Work Order ID 73627

Item Name: Basket Hoop

DESIGN #	DRAWN BY CP	DART AEROSPACE LTD HAWKESBURY, ONTARIO, CANADA	
CHECKED #	APPROVED #	DRAWING NO. D3166	REV. A SHEET 1 OF 1
DATE 02.07.10		TITLE BASKET HOOP	SCALE NTS
A	02.07.10	NEW ISSUE	
A1	04.04.08	38+/-1 WAS 36.0

DRAWING NO. D3166	TITLE BASKET HOOP	REV A1	DART AEROSPACE LTD ENGINEERING ORDER		D.E.O. NO. D3166-A-2	SHEET NO. 1 OF 1	SCALE NTS
DRAWN AJS	CHECKED <i>[Signature]</i>	MFG. APPR. <i>[Signature]</i>	APPROVED <i>[Signature]</i>		DE APPR. <i>[Signature]</i>		
DATE 08.12.11	DATE 08.12.15	DATE 08/12/15	DATE 08/12/16		DATE 08.12.16

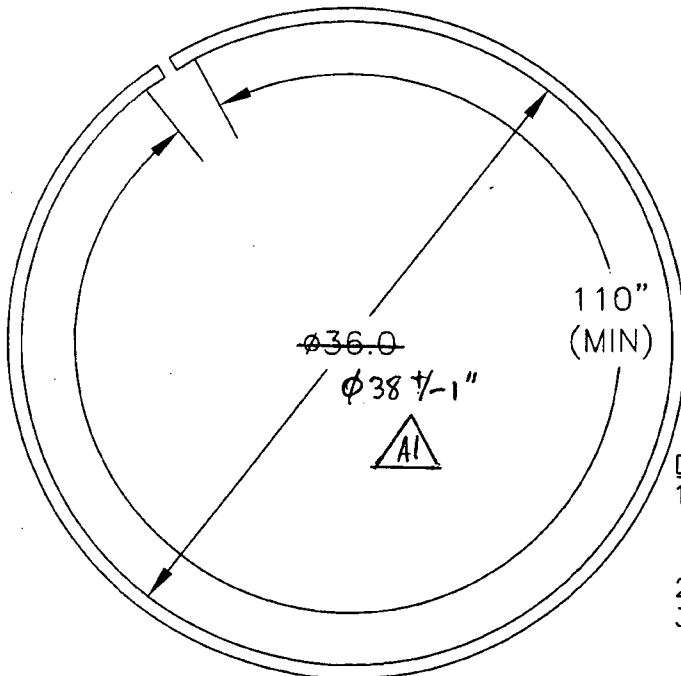
1) MODIFY MATERIAL NOTE FOR D3166-1 AS SHOWN:

WAS:

1) MATERIAL: AISI 304/316 SS SQUARE TUBING,
0.75" x 0.75" x 0.063 WALL, 60.00" LONG
(REF DART SPEC. M304TS0.750W.063)

2) MODIFY MATERIAL NOTE FOR D3166-3 AS SHOWN:

WAS:

1) MATERIAL: AISI 304/316 SS SQUARE TUBING,
0.75" x 0.75" x 0.063 WALL, 120.00" LONG
(REF DART SPEC. M304TS0.750W.063)

REASON: SEE PAR 08-005

IS:

1) MATERIAL: AISI 304/316 SS, 3/4 X 3/4 X 0.065 WALL SQUARE TUBING,
60.00" LONG
REF. DART SPEC M304TS0.750W.065

IS:

1) MATERIAL: AISI 304/316 SS, 3/4 X 3/4 X 0.065 WALL SQUARE TUBING,
120.00" LONG
REF. DART SPEC M304TS0.750W.065
